10th Street Complete Streets Study Project Visioning Team Meeting #2

Meeting Record

Date : Wednesday, February 2, 2022 at 2:00 p.m

10th Street Corridor Study

Medical Arts and Historic Grid – Proposed

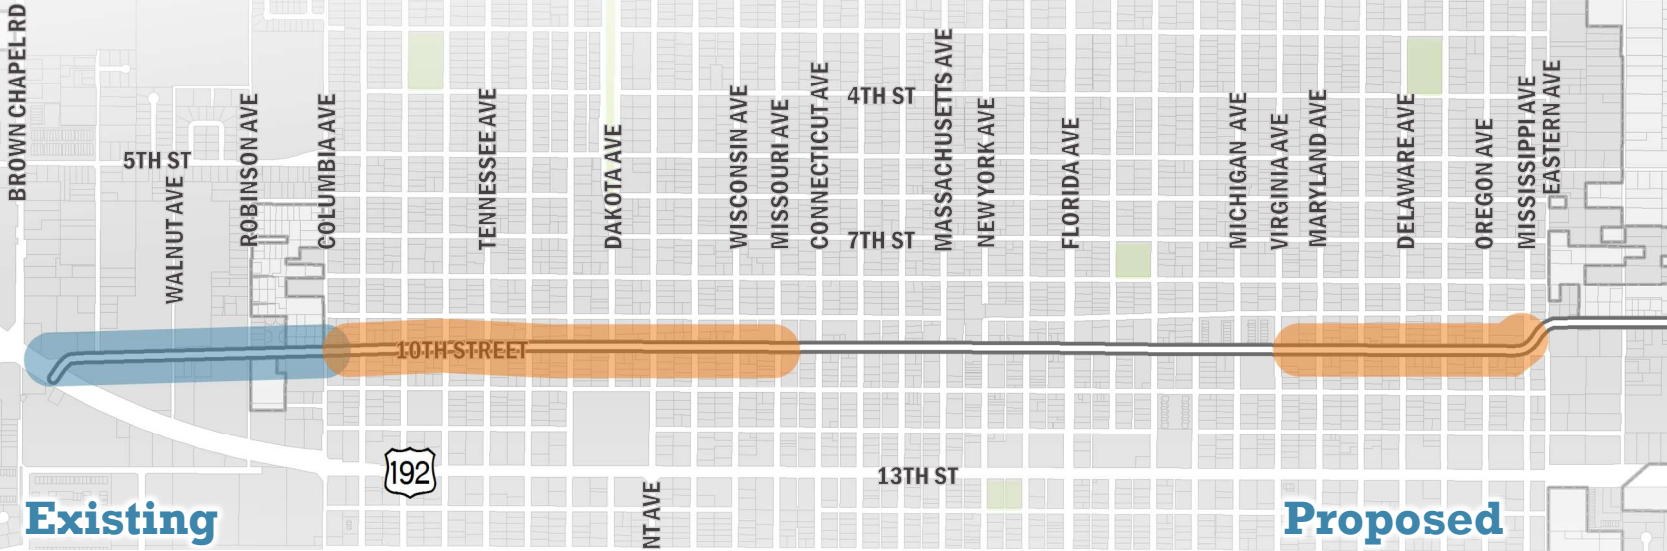
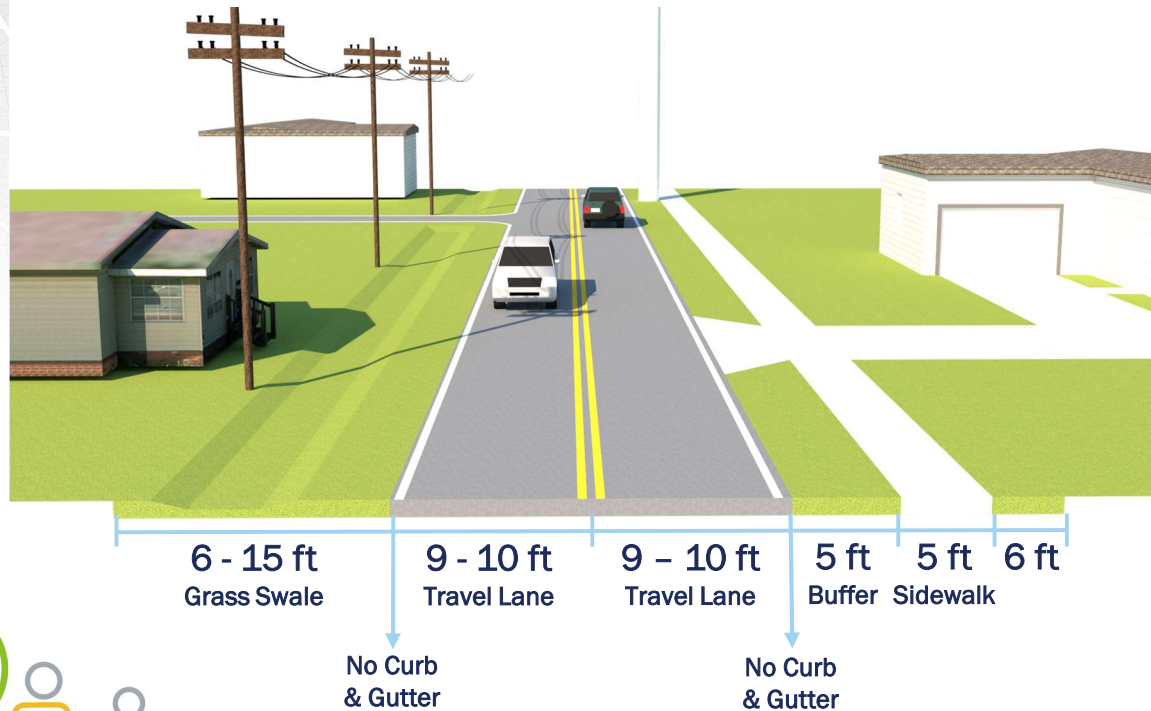
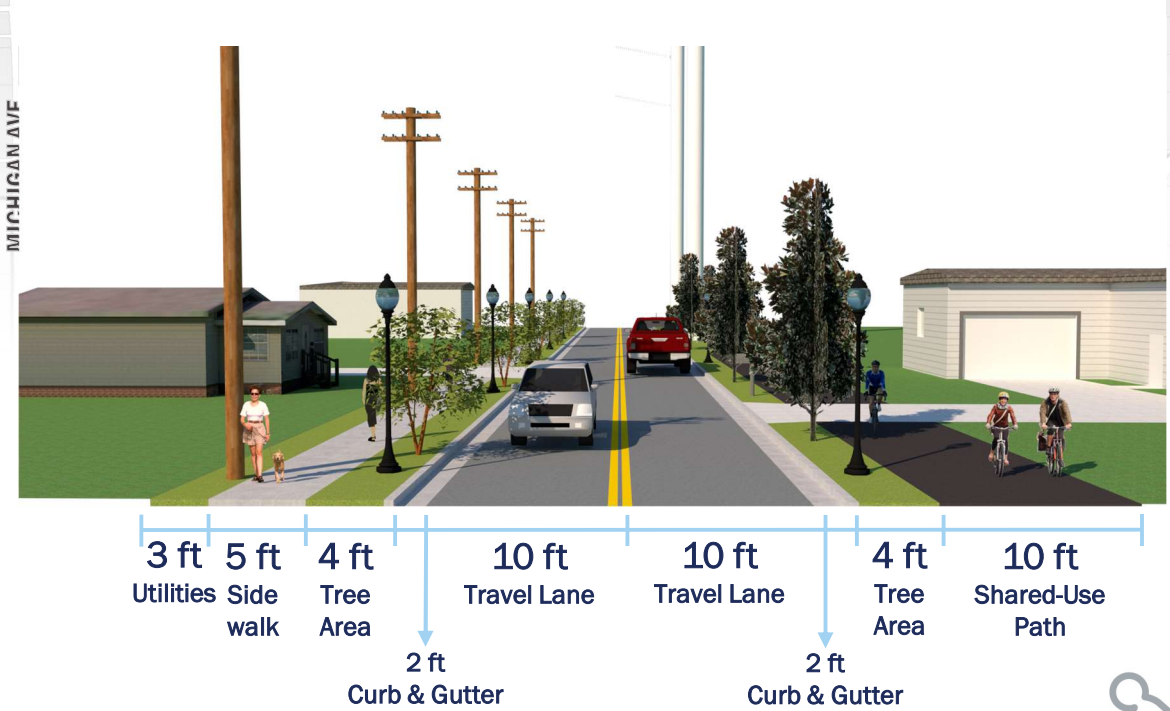
Ms. Emily Hanna, Bike/Walk Central Florida, submitted a comment through the Zoom chat feature: “Don't be afraid to ask for the energy provider to move those larger transmission lines as well. They will if you can show the public benefit.” Mr. Jeff Arms responded that it is still usually very expensive and difficult to accomplish with the right-of-way.

Ms. Paula Stark, St. Cloud Main Street, commented through the Zoom chat feature: “Relocating power poles would probably be necessary. Input on power poles as a whole being addressed to consistent style poles would be more pleasing.”

Mr. Adonis Willis, OUC, commented through the Zoom chat feature: “The smaller wooden distribution poles are much easier to deal with in terms of relocating.”

Ms. Emily Hanna suggested through Zoom chat “Or underground them?! Not the transmission lines, I understand that.”

Mr. Adonis Willis said that the wooden power poles are much easier to move or underground than the steel ones. The steel power poles have more time constraints, have to get approval from commission, and have other considerations.

Ms. Erin Sterk spoke up saying she had two questions. The first question was in regard to the Medical Arts & Historic Grid typical. She asked if there are power poles on one side of the road; why is that side of the street where the shared-use path is? Is it more feasible? Ms. Megan Ferguson responded that yes, with the way that the right-of-way exists it is more feasible to have the shared-use path on that side of the road to meet minimum offset criteria and to avoid additional roadway shifting. The study team offered to continue to evaluate the north side. Mr. Erin Sterk understood, saying there’s always logic to what is being done. Her second question was in regard to the Historic Grid. In some locations, the study team mentioned moving the centerline, which can cost a lot. Does the study team have the number of locations where the centerline will move or a marker map to share with the city? Ms. Megan Ferguson replied that this information will come during the concept development phase. Mr. Jeff Arms agreed, saying that we will determine more dimension details in the next phase, we have looked at some details, but not every block has been determined.

Historic Core – Proposed

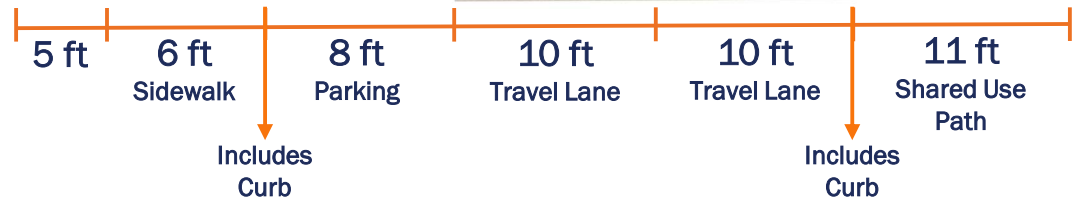
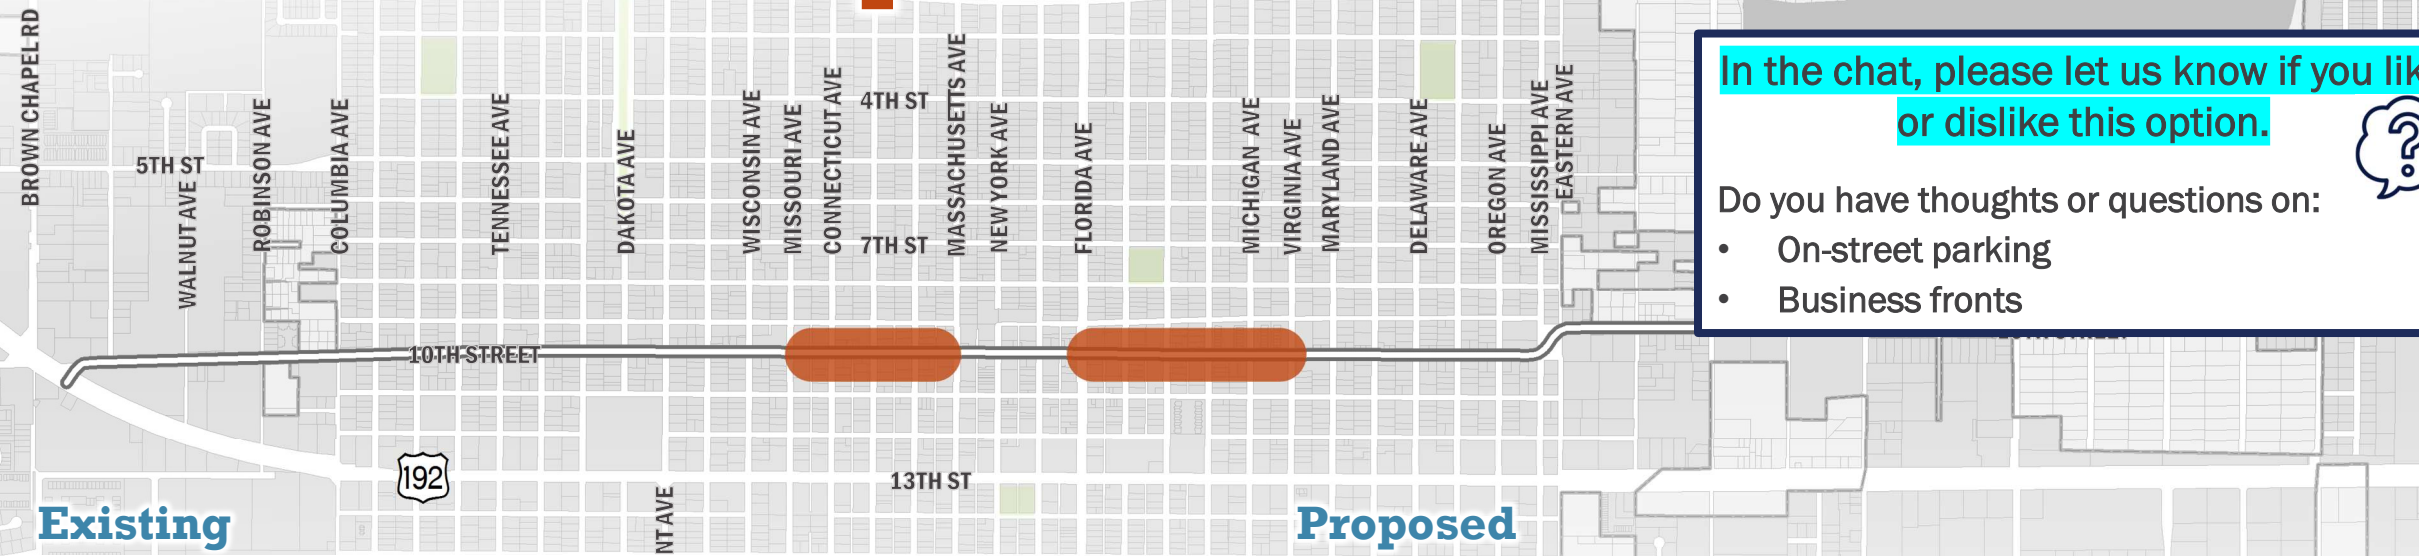
Ms. Megan Ferguson reviewed the typical option for the Historic Core. Ms. Erin Sterk asked about the parking that is located on one side of the street, and there is similar pedestrian access on either side, is it assuming that the right side of the typical is the north? Mr. Jeff Arms responded that they are in the process of determining the side of the street where parking will be located. Ms. Sterk said that this cross section has a lot of things the rest of the corridor doesn’t have. She said that parking should be on the south side of the road, since places will likely be converted to commercial use on the south side of the road, and there will be less commercial use on the north side of the road between 10th Street and 13th Street, which is potentially safer for pedestrians and cyclists.

Suburban Transition – Proposed

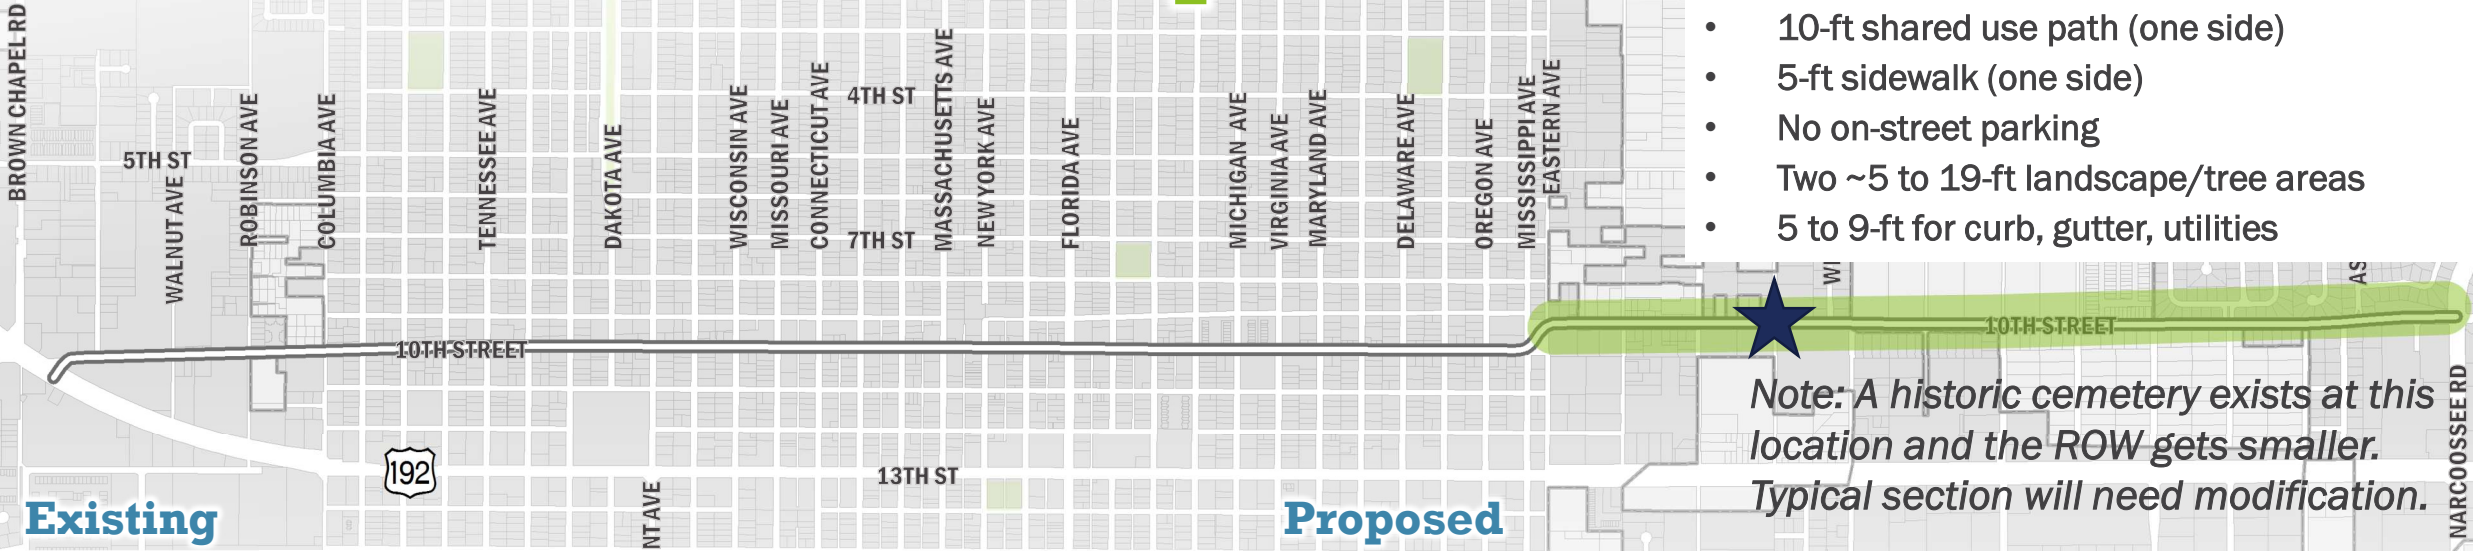
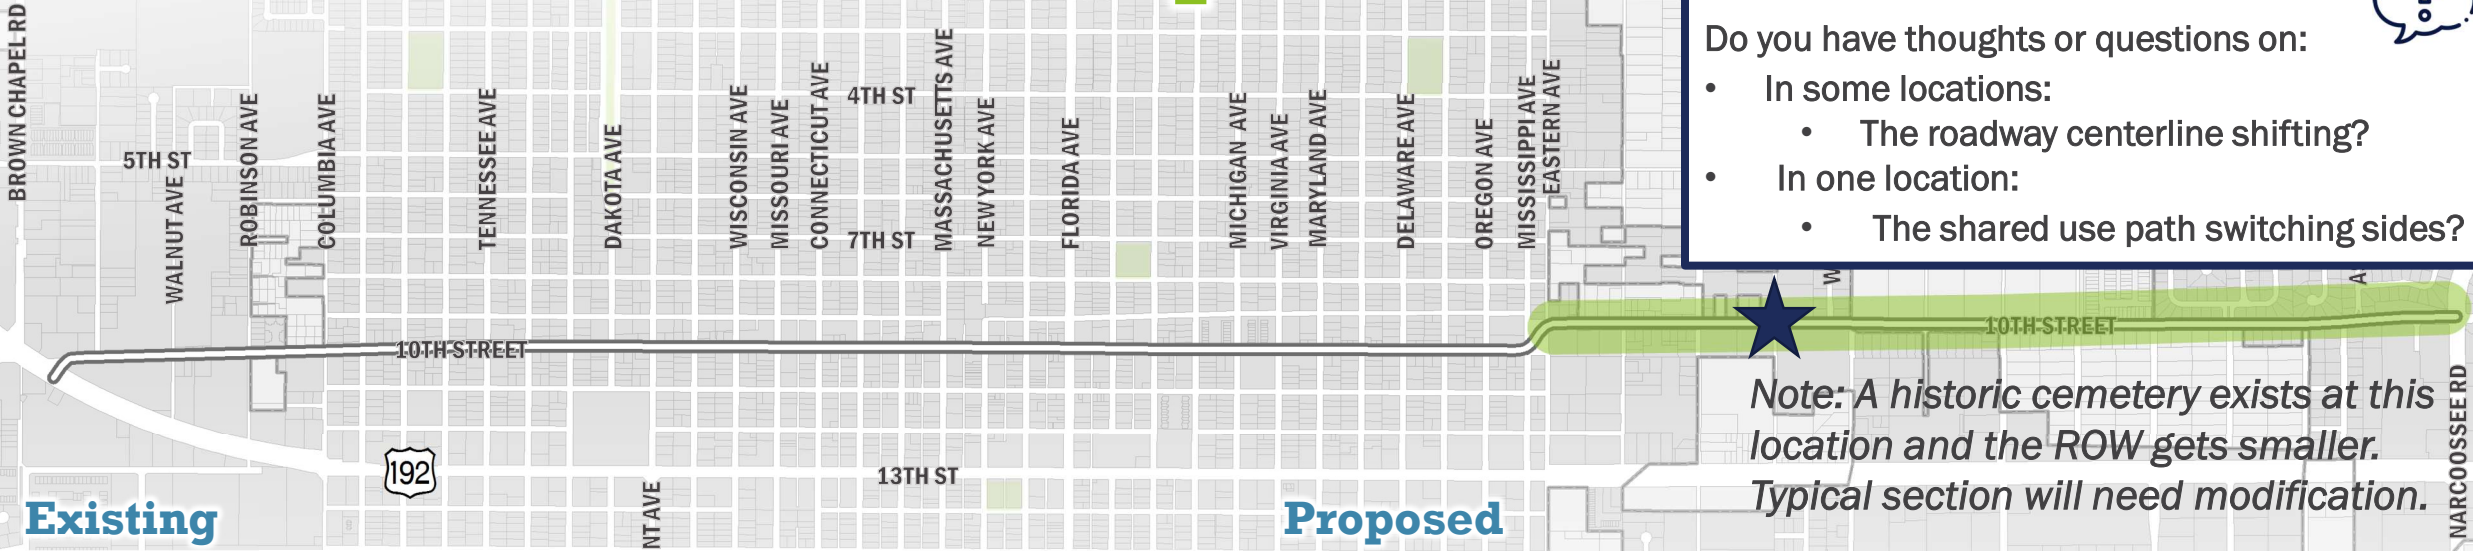
Ms. Ferguson reviewed the Suburban Transition proposed typical. Ms. Christina Morris said that she lives near the cemetery in the Suburban Transition segment and likes the proposal. Ms. Erin Sterk said in relation to the cemetery, the city maybe be willing to give an easement for a full 60 feet of right-of-way next to the cemetery if needed. Ms. Melissa Porcaro reviewed the current results of the survey in relation to the three typical segment proposals and some of the open-ended comments.

Possible Intersection Alternatives

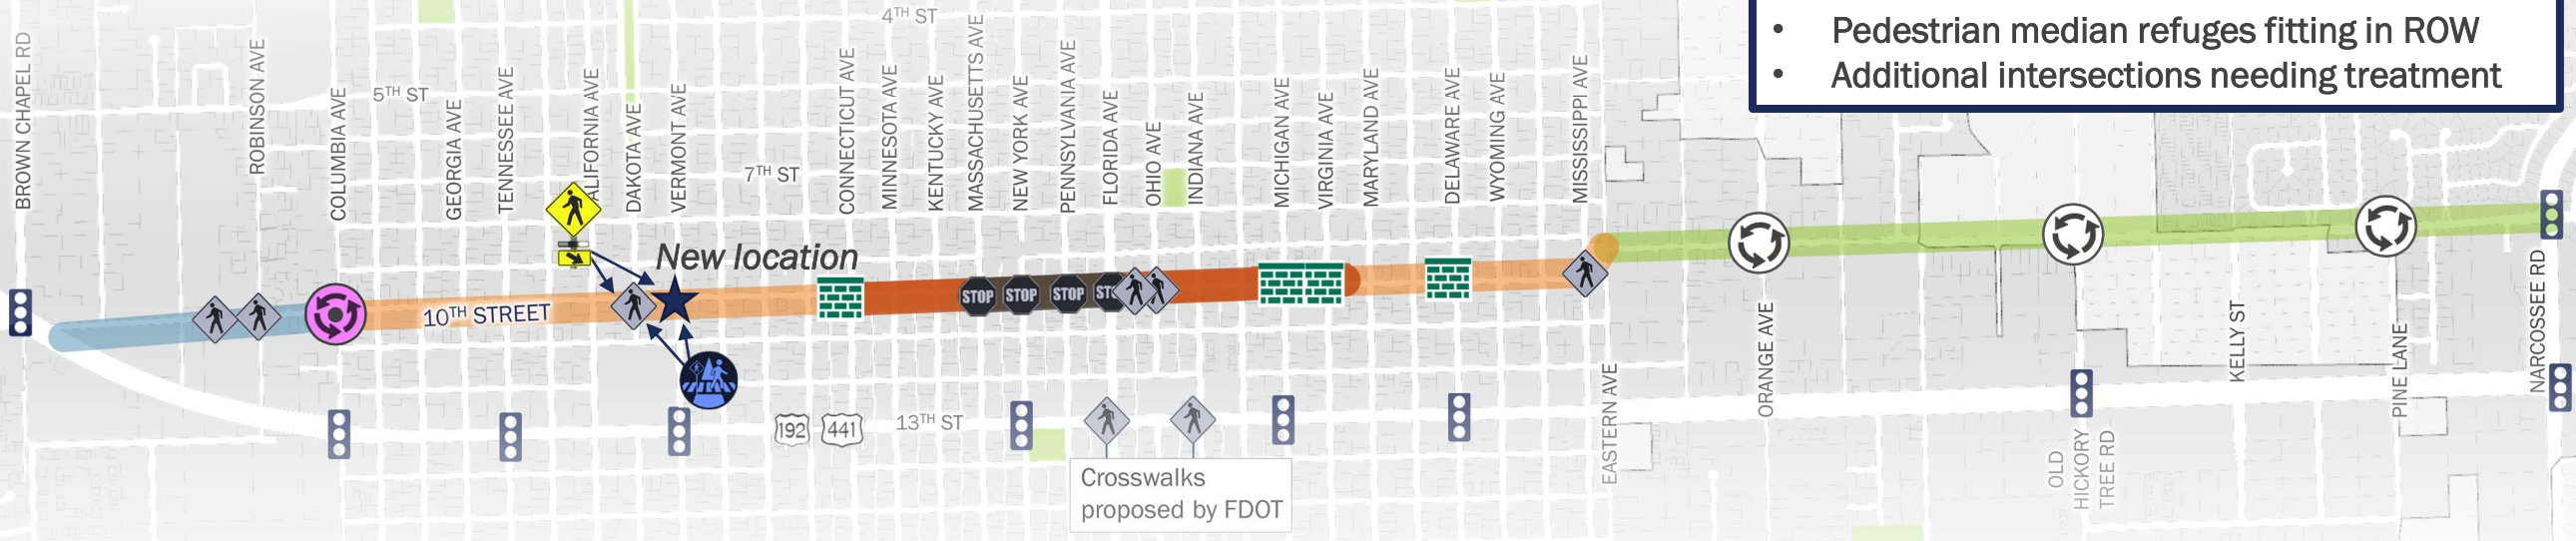
Ms. Paula Stark said over the Zoom chat feature in relation to the intersection solutions: “Painted intersections would not be conducive to the historic character of the historic district. Which raises the question as to whether this information will go in front of the Historic Preservation Board for input. I'm also concerned about the mini roundabouts especially at Orange.” Mr. Jeff Arms said that they would defer to the city about the Historic Preservation board, we are laying out a vision for concepts, but that might have to go before the board during the design phase.

Ms. Emily Hanna said that one thing she wanted to mention was at the Robinson crosswalk there is a mobile home park, and a lot of the residents walk there. Ms. Hanna further spoke in the Zoom chat: “You can paint them in more muted/historic tones. I've seen them painted brown in mountain towns out west.”

Ms. Paula Stark clarified on her Orange Ave comment using the Zoom chat feature: “I live on Orange Ave. I have experienced the ones in Kissimmee in similar areas. The traffic increase seems like it would be more problematic.”

Ms. Beverly Hughes said using the Zoom chat feature: “Pedestrian Median Refuge is not the best choice near schools due to excessive supervision/law enforcement intervention to enforce compliance by pedestrians.” Mr. Jeff Arms responded that he's not sure why a Pedestrian Median Refuge would have the need for extra law enforcement. Ms. Emily Hanna spoke up saying there's a couple of conditions with landscaping that can keep people from seeing kids in the intersection. She said we never collect data when the crossing guards are out because we never want to distract them, but has not heard that. Ms. Hughes responded in the Zoom chat saying “The location identified is not qualified for crossing guards.”

Mr. Jeff Arms asked if there were any intersections the study team missed for intersection improvements. Vermont Avenue was mentioned from the public involvement, and Tennessee Avenue already has a traffic signal on US 192. Ms. Erin Sterk said at Florida Avenue the parks department has been trying to put sidewalks on either side with a median bike trail. Because of that, there may be extra users on that corridor and they're not sure how to deal with that crossing. Mr. Arms said that there is a 4-way stop right now and that intersection is part of the downtown final design that is on-going. Ms. Sterk said that it was a unique circumstance. Mr. Alex Trauger added that it was a section already under design by the city.
